product modification

040-0276-00

Type 575

INCREASED COLLECTOR VOLTS

FIG. 5

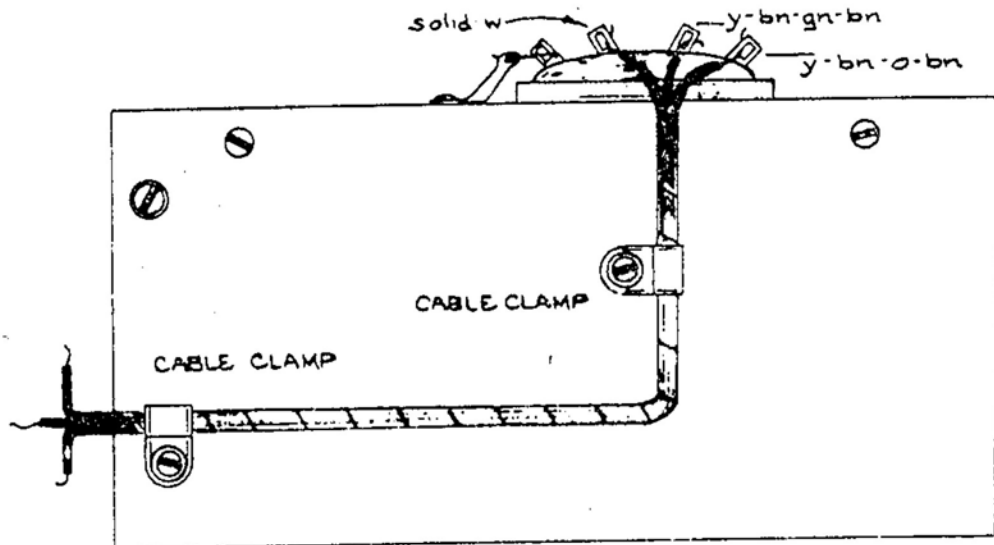
- () 14. Mount the cable assembly* (from kit) on the side of the C.S. box with the two cable clamps (from kit). See Fig. 5. Use the 6-32 PHS screws, flat washers, lockwashers and nuts from the kit.

- () 51. Solder the three wires to the transformer terminals, as shown in Fig. 5.
- () 52. Solder the white-blue wire from the PEAK VOLTS RANGE switch to the lower terminal of C706A.
- () 53. Solder the white-violet wire from the PEAK VOLTS RANGE switch to the lower terminal of C706D.
- () 54. Solder the no. 22 white-yellow solid wire from the 11-notch ceramic strip, on the support plate, to C706E.
- () 55. Solder the white-yellow stranded wire from the support plate assembly to the POLARITY switch, as shown in Fig. 10.
- () Solder the white-yellow stranded wire from the POLARITY switch to terminal 8 of T703.

FIG. 6

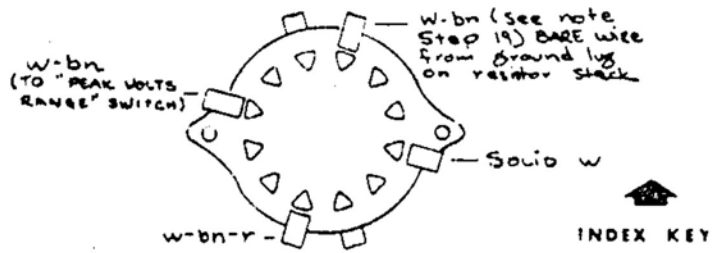
- () 19. Install the new POLARITY switch (from kit) and solder the wires to it, as shown in Fig. 6.

NOTE: There were two white-brown wires previously connected to the POLARITY switch. Connect only the one which is dressed through the grommet in the front of the C.S. box (check with ohmmeter) to the new POLARITY switch. The other one will connect to the PEAK VOLTS RANGE switch, as called out in Fig. 7.

FIG. 7

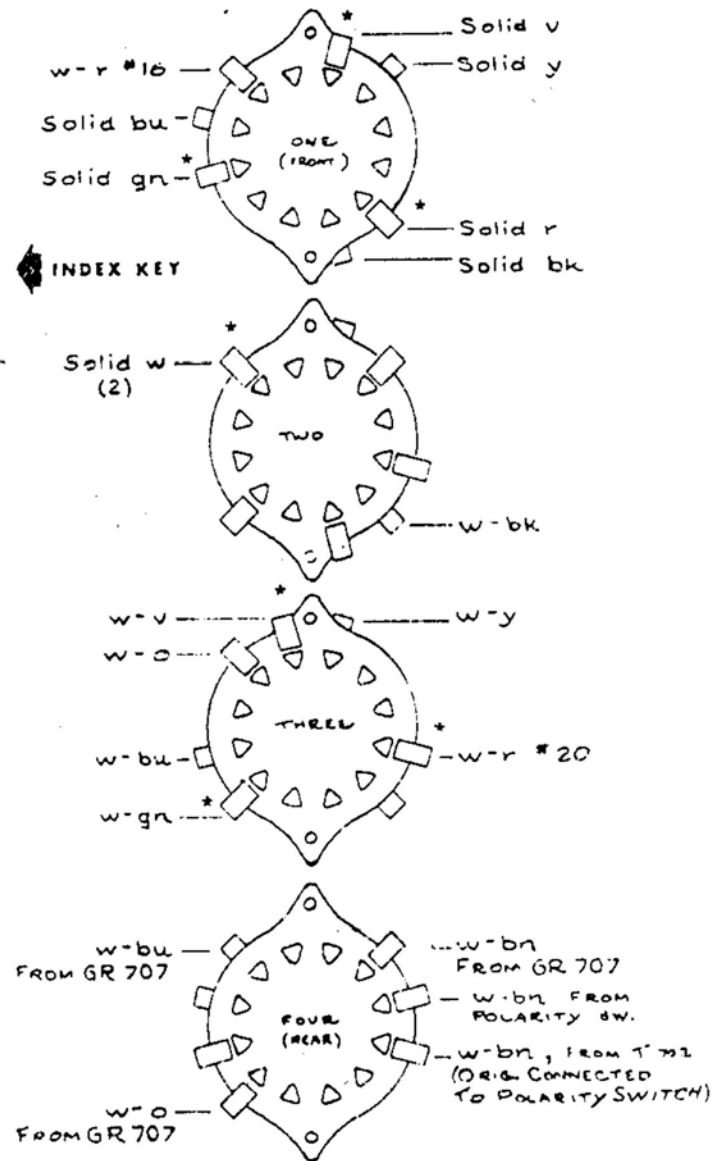
*These are double contacts; one on the front of the wafer and the other on the rear. Solder the wire to both contacts.

FIG. 8

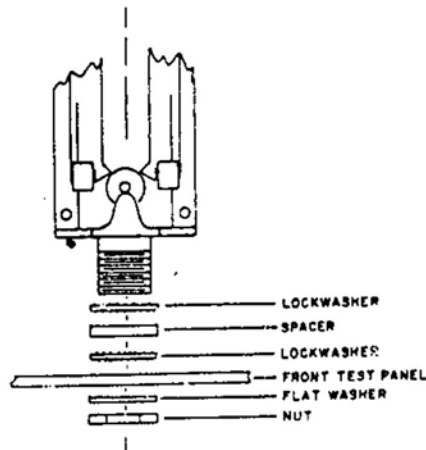
- () 32. Enlarge the Transistor Selector switch mounting hole in the Test Panel to 1/2 inch, using a drill or reamer.
- () Install the Transistor Selector switch (from kit) as shown in Fig. 8. Orient switch so that the white-green wire comes out to the TRANSISTOR B side.

FIG. 9

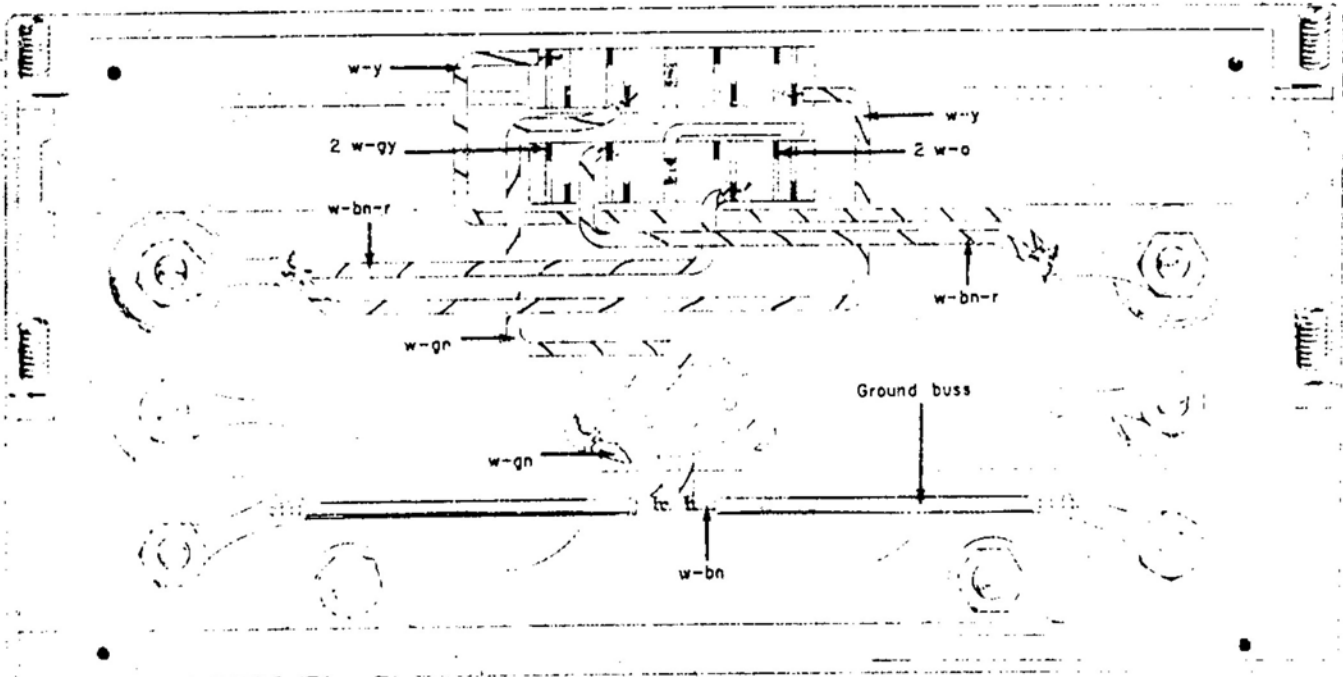
- () 33. Add a ground lug, a no. 16 buss wire and two lengths of tubing (from kit), as shown in Fig. 9. (Disregard this step for instruments which already have a ground buss.)
- () 34. Solder the white-green wire from the Transistor Selector switch to the center of the ground buss (see Fig. 9).

- () 35. Solder the white-green wire from EMITTER GROUNDED - BASE GROUNDED switch to the center of the ground buss (see Fig. 9).

- () 36. Solder the two white-yellow wires from the Selector switch to the Collector Test terminals, as shown in Fig. 9. (Some instruments already have two white-yellow wires connected to the test terminals. If so, remove and discard them.)
- () 37. Solder the two white-gray, the two white-orange and the two white-brown-red wires to the Selector switch, as shown in Fig. 9.

FIG. 12

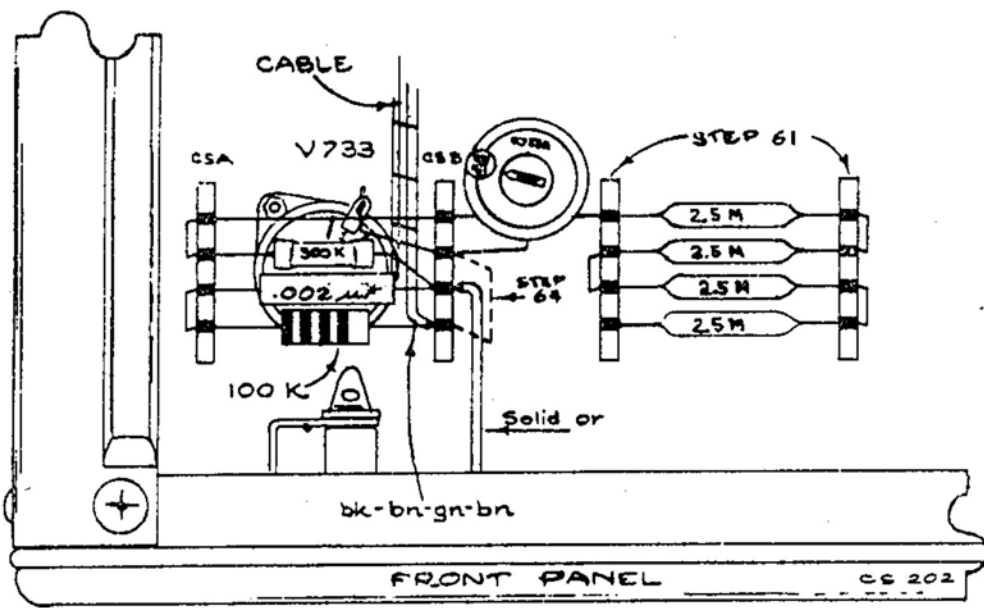
- () 61. Insert four nylon spacers (from kit) in the holes just drilled and press the two 4-slot ceramic strips (from kit) into them. (See Fig. 12).
- () 62. Unsolder and remove all the components on the 4-slot ceramic strips mounted over the V733 tube socket. SAVE THE 100k, 1W RESISTOR FOR RE-USE.
- () 63. Remove C735 (variable ceramic capacitor).
- () 64. Unsolder the solid orange, the two white-yellow wires, and the bare jumper wire from CSB (see Fig. 12).
- () Unsolder the bare wire from CSA to -in-1 of V733.
- () 65. Unlace the three wires (just unsoldered) back to the grommet.
- () Discard the short white-yellow wire, which is now free.
- () 66. Unsolder the black-brown-green-brown wire from CSB and resolder it, as shown in Fig. 12.

- () 67. Resolder the solid orange wire to the point vacated by the black-brown-green-brown wire in step 66 (see Fig. 12).

- () 69. Wire all four ceramic strips, as shown in Fig. 12.
- () 70. Wire the Transistor Selector switch and connect the two high voltage leads to the ceramic strips, as shown in Fig. 13.

Fig. 14A BEFORE

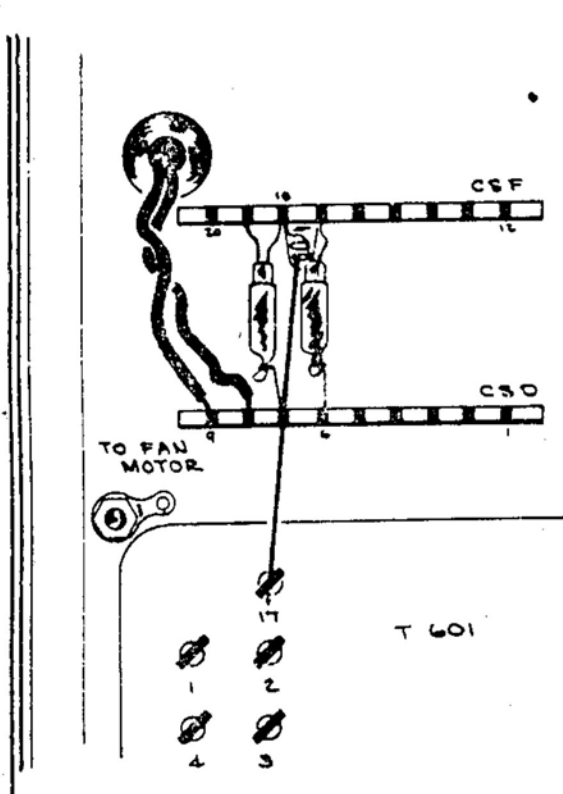
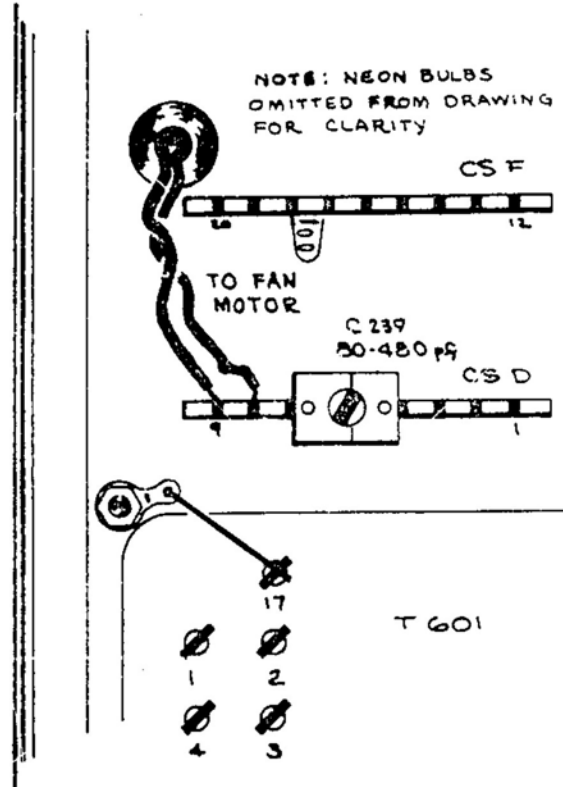
- () 71. Move the neon holder from CSD-7 to CSD-6. See Fig. 14A for locations.
- () If a bare wire is connected from terminal 17 of T601 to CSD-7 to the ground lug indicated in Fig. 14A, remove this wire completely; instead, install a #16 bare wire (from kit) between terminal 17 and the ground lug shown in Fig. 14B. (If no lug is present, install a #10 solder lug from the kit.)

- () 72. Connect a 7-1/2 inch length of #22 solid white wire (from kit) from CSD-4 to the solder lug installed in step 44.
- () Connect a 3-1/2 inch length of #22 solid white wire (from kit) from terminal 14 of T601 to CSD-7. See recalibration instructions.

- () Install C239, an 80-480pF capacitor (from kit) between CSD-4 and CSD-7. See Fig. 14B.
- () 73. Carefully unsolder all the wires from the HORIZONTAL VOLTS/DIV switch.

FIG. 15

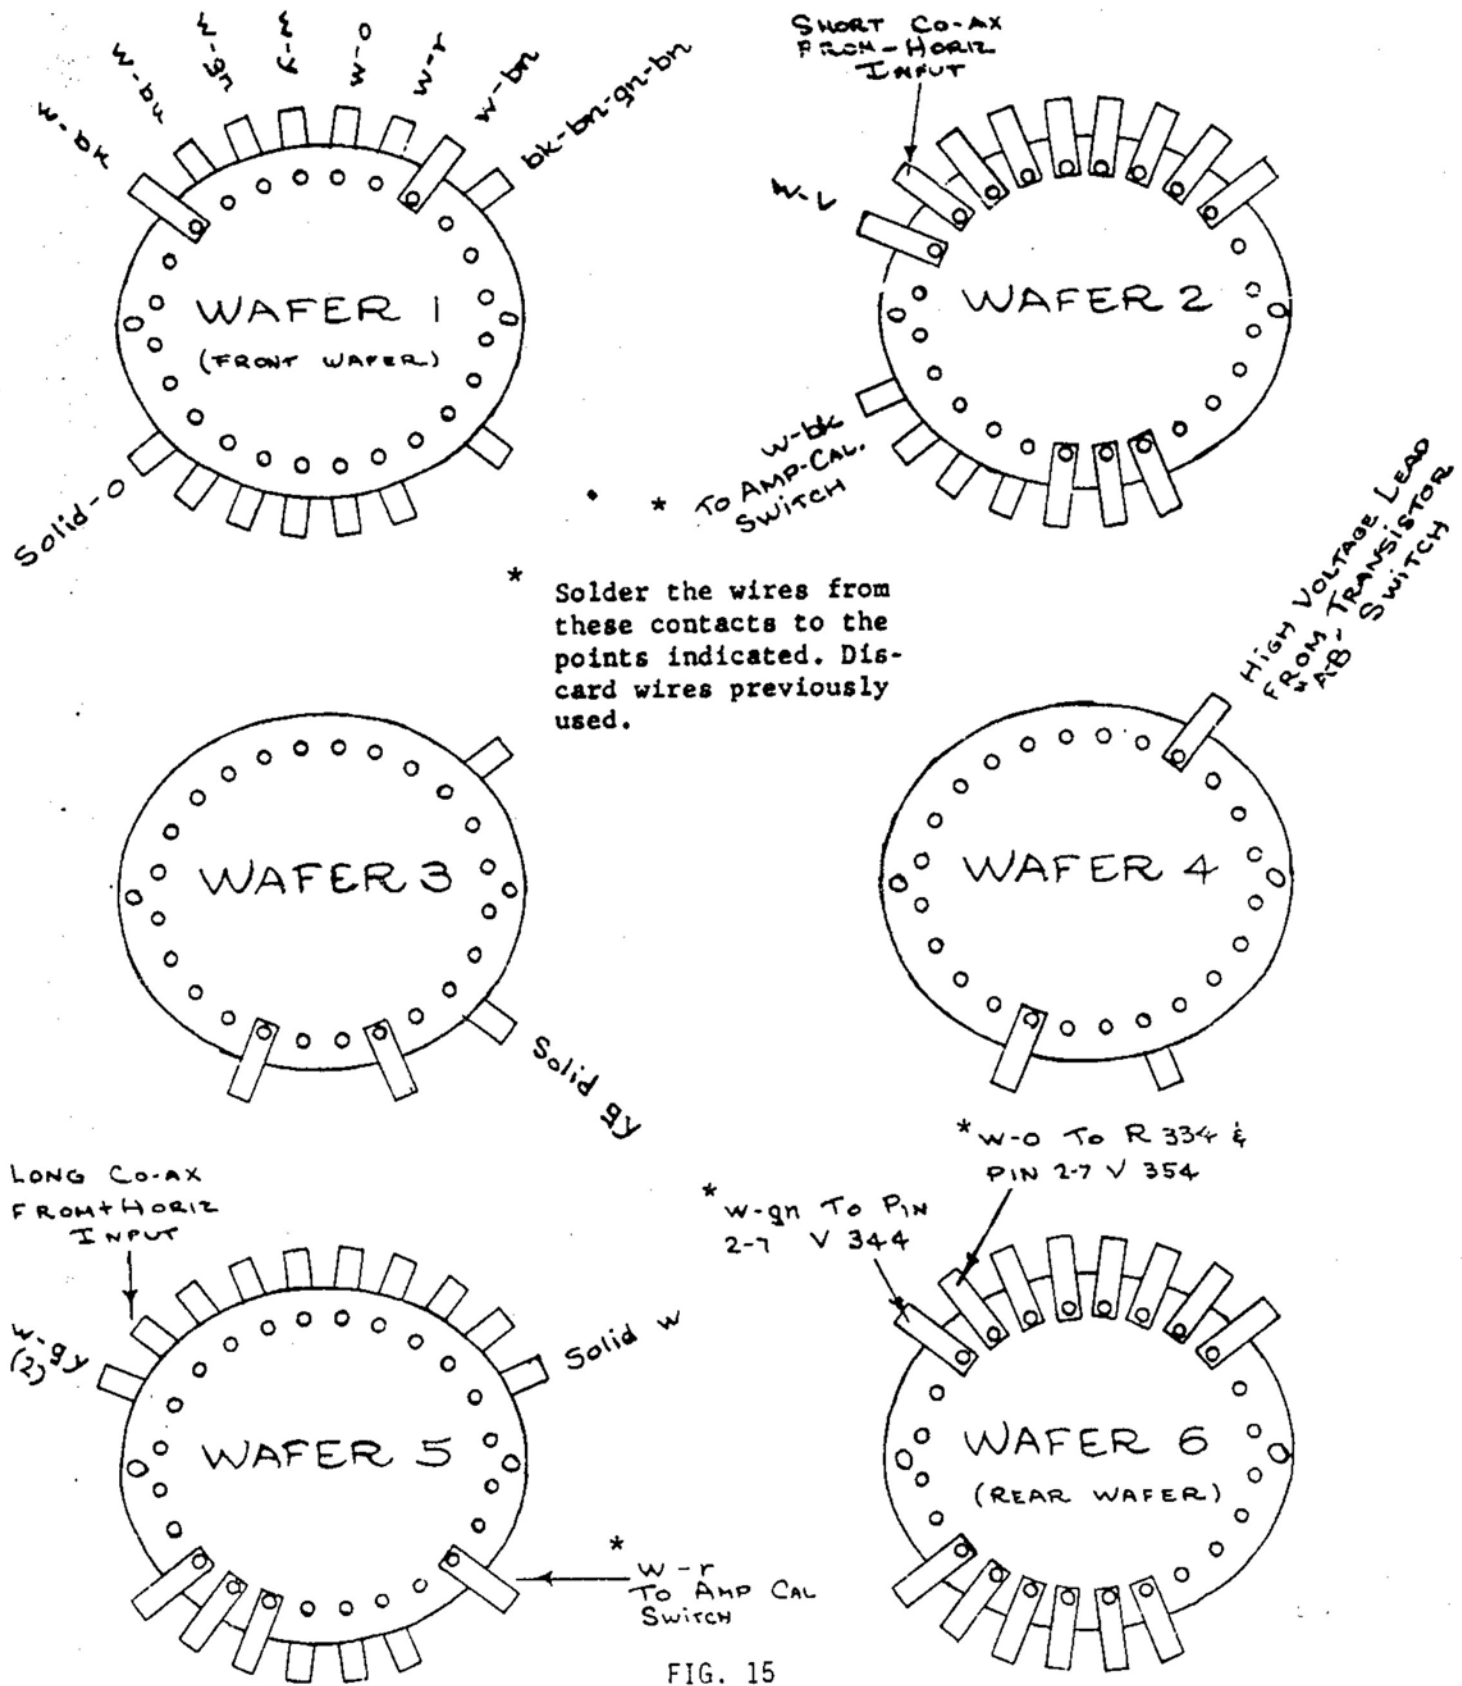
- () 77. Solder the wires to the switch as shown in Fig. 15.

NOTE: Potentiometers R334 and R434, previously mounted on rear bracket of HORIZONTAL VOLTS/DIV switch, are now mounted on the printed circuit board attached to rear of switch. In instruments BELOW SN 822, R334 was mounted on HORIZONTAL VOLTS/DIV switch and R434 was mounted on VERTICAL CURRENT OR VOLTAGE PER DIVISION switch.
